Planning Permission

Reference: H23/0320/93

Description: Lounge and bedroom extension

Location : Cherry Trees Saltney Gate
Saracens Head Spalding

SIDE.

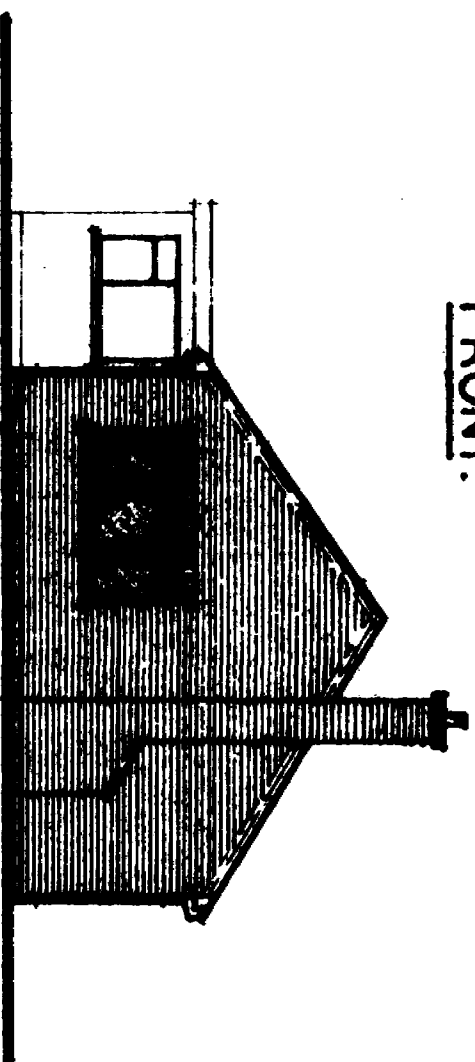
One less window on end elevation.
